**Appendix C:**  
**Updated Cemetery Plan and Wastewater Treatment**  
**Details; Cordoba Center Project**

Subject: Updated Cemetery Plan and Wastewater Treatment Details;  
Cordoba Center Project, Santa Clara County

SITE IMPROVEMENT  
FOR  
CORDOBA CENTER  
MONTEREY ROAD  
SANTA CLARA COUNTY, CA  
APN # 779-06-02

CEMETERY GRADING PLAN

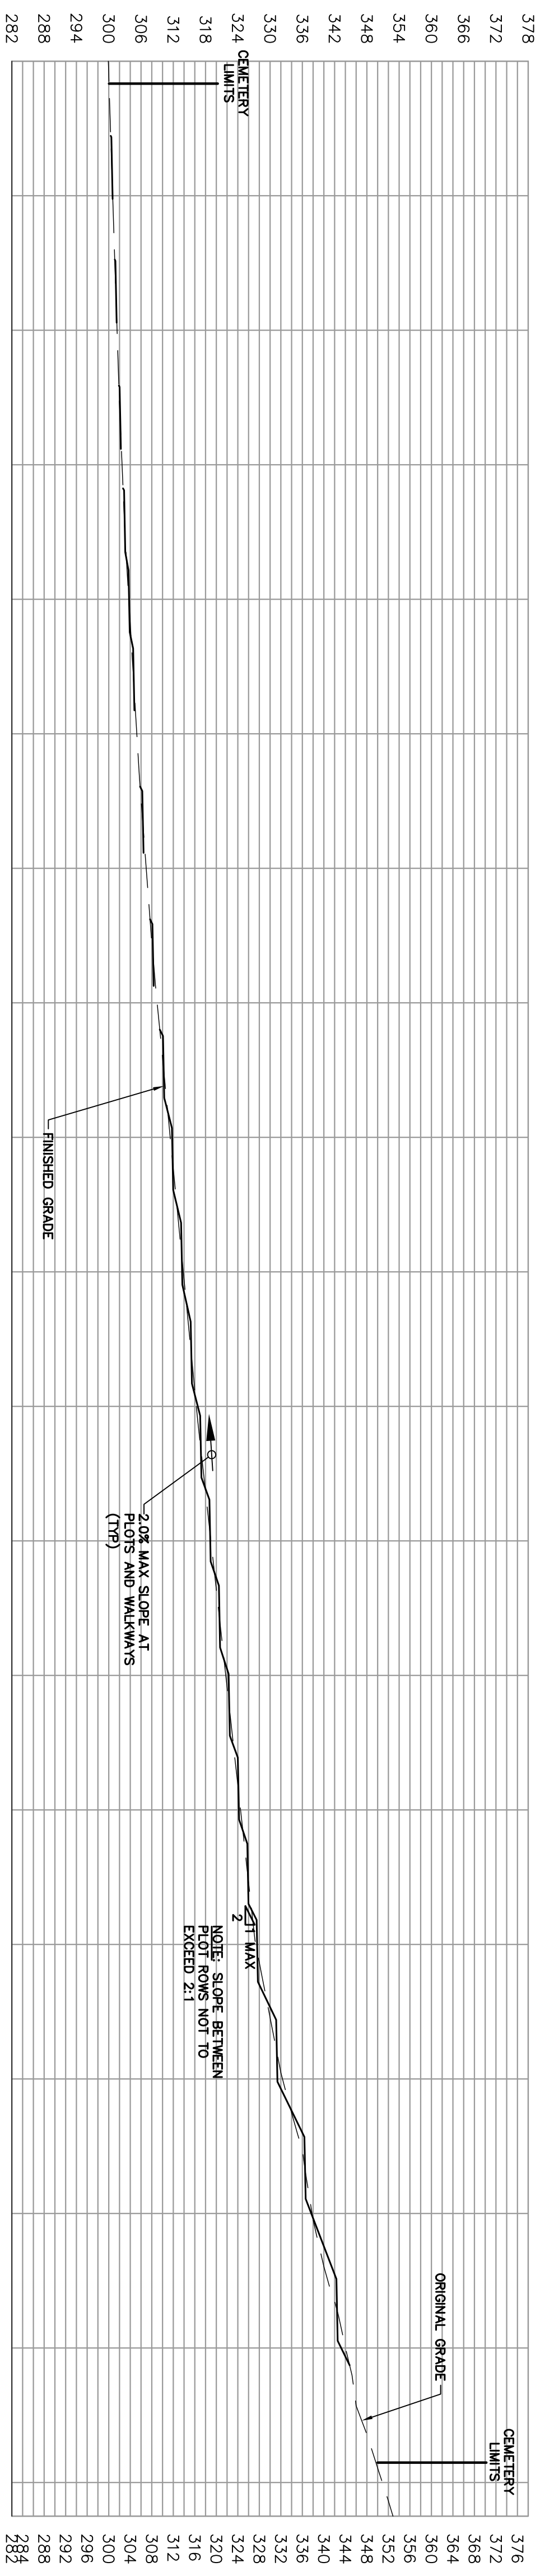
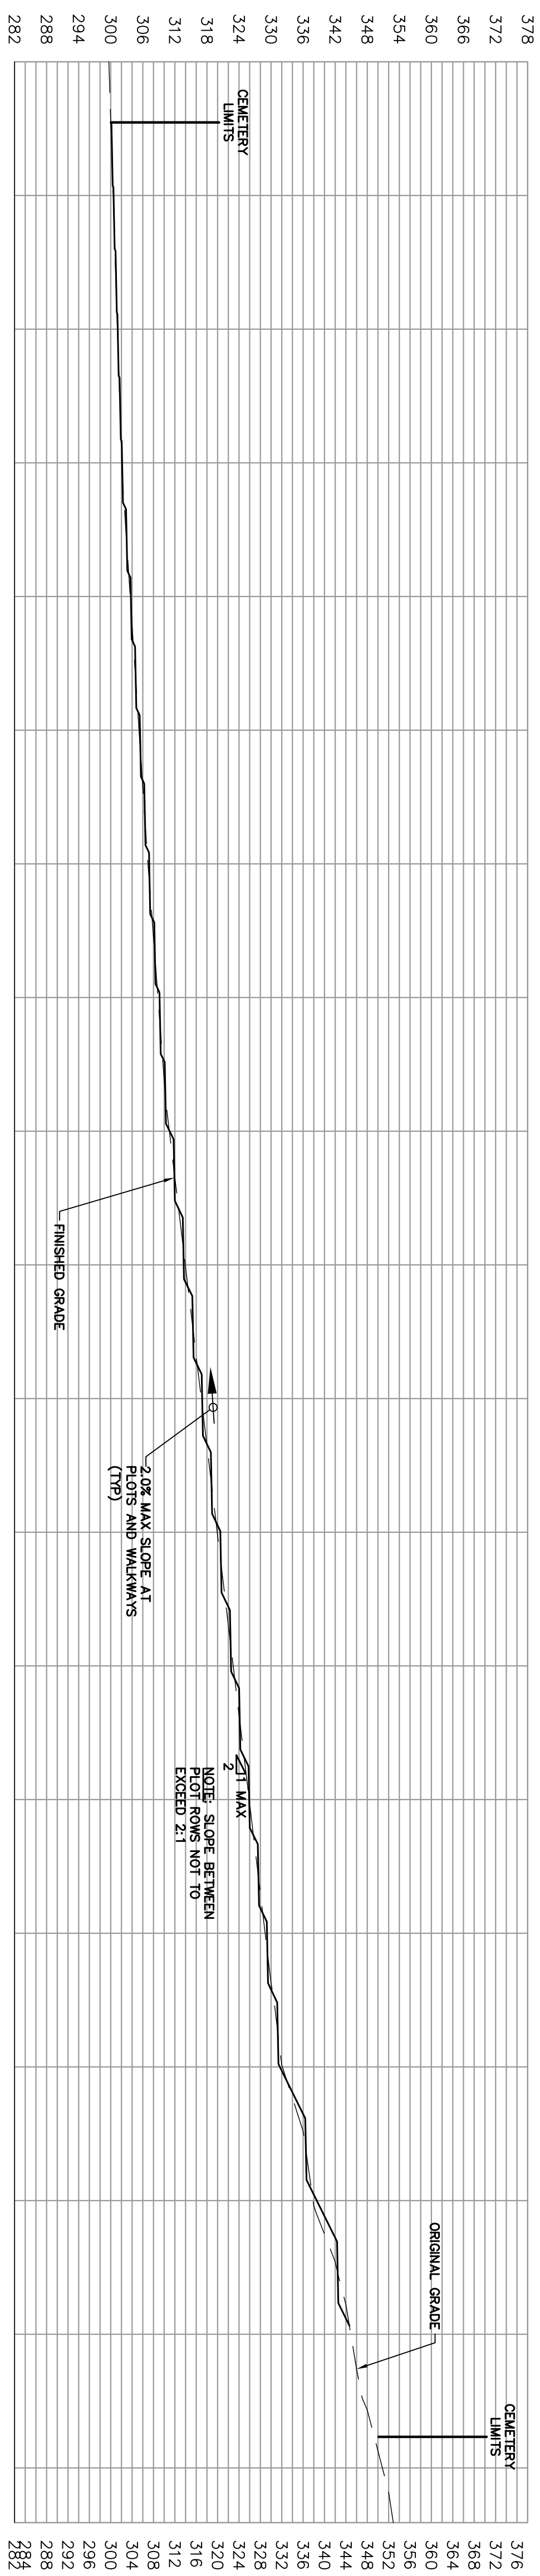
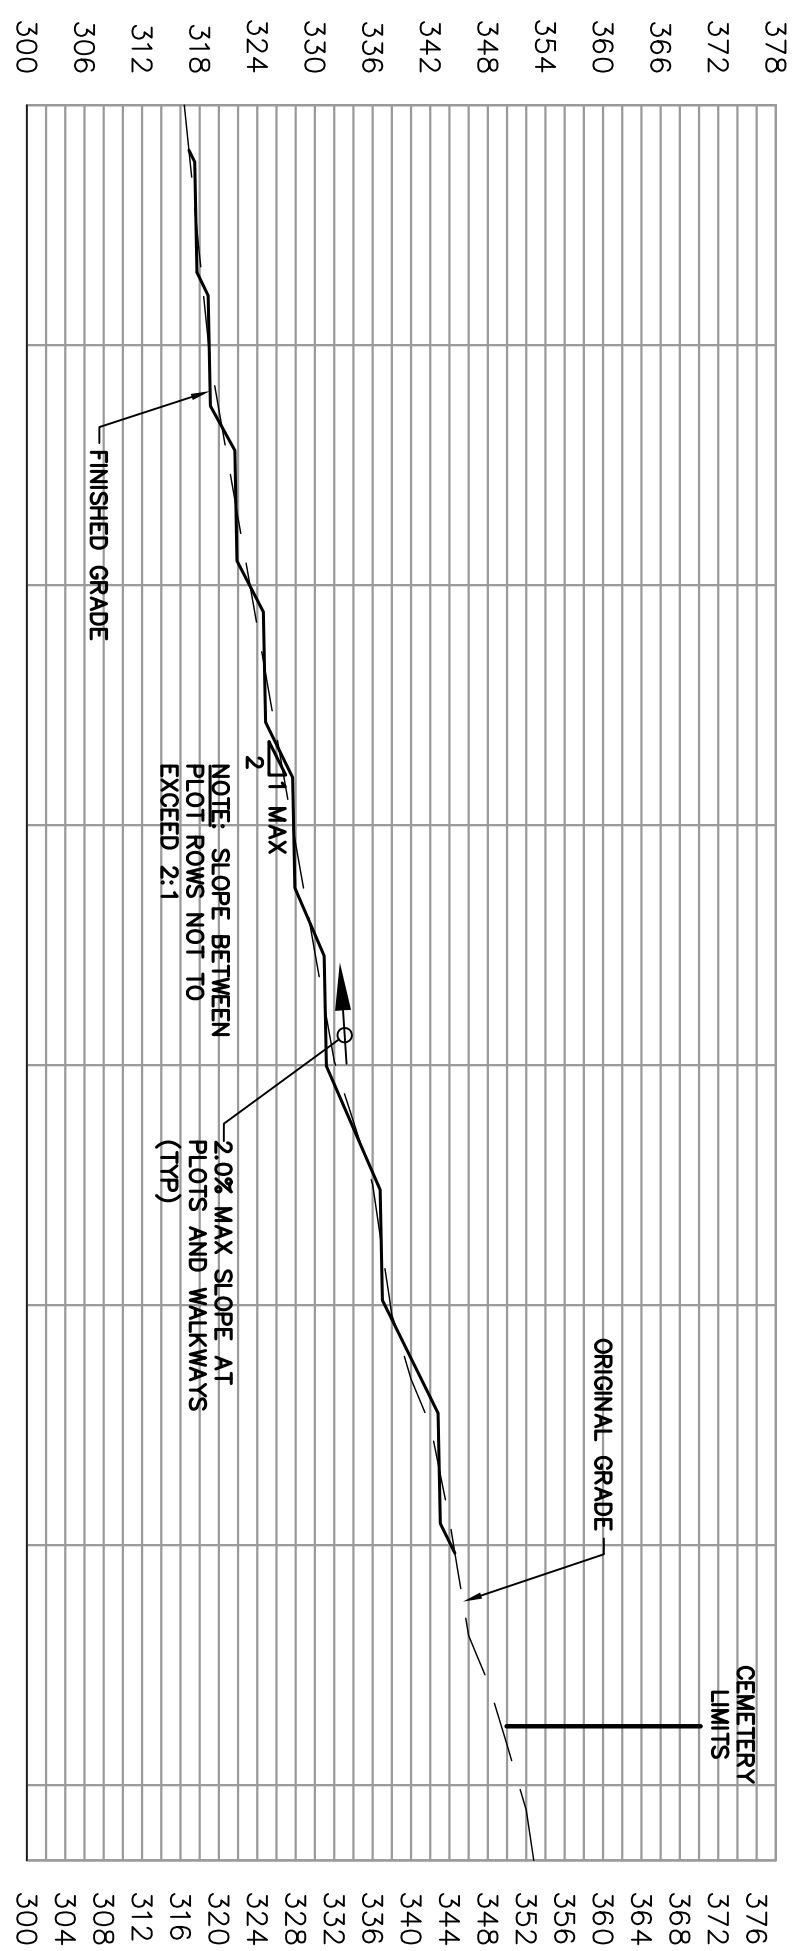
**Grading.** Our review of the updated grading plans indicates the proposed cemetery grading to be substantially the same as shown in the preliminary plans, consisting of graded burial terraces conforming closely to the native hillside contours, with relatively small cut and fill slopes 1 to 2-feet high.

**Cemetery Burial Details.** The updated Cemetery Plan Detail shows the dimensions and spacing of typical burial plots, the planned layout of burials through-out the entire cemetery, and a proposed plan for phasing the burials over time. The preliminary plan for the cemetery available during preparation of the DEIR was diagrammatic and gave a general estimate of 1,200 burials per acre, or roughly 4,200 potential burials for the 3.5-acre cemetery. The updated plan shows the total number of burials to be approximately 1,600, grouped into five sequential phases. The notes on the plan indicate that each burial phase will be completed before beginning burials in

the next phase. Phases 1, 2 and 3 are all located east of the central access road, and contain just over 800 burial sites. Phases 4 and 5 are west of the access road, containing just under 800 burial sites. Based on our review, the new information provided in the Cemetery Plan Detail is consistent with the preliminary information on which Questa's prior review was based. Also, the proposed burial phasing plan agrees with the recommendations made by Questa to sequence the burials beginning in the northeastern corner of the cemetery, and proceeding downhill and westerly. This will maintain maximum buffer distance between the graves and the westerly property line during the initial years of operation, providing the opportunity to measure actual groundwater impacts of the burials, and make adjustments as needed going forward. No changes to the water quality impact analysis are warranted based on the updated plans for the cemetery.
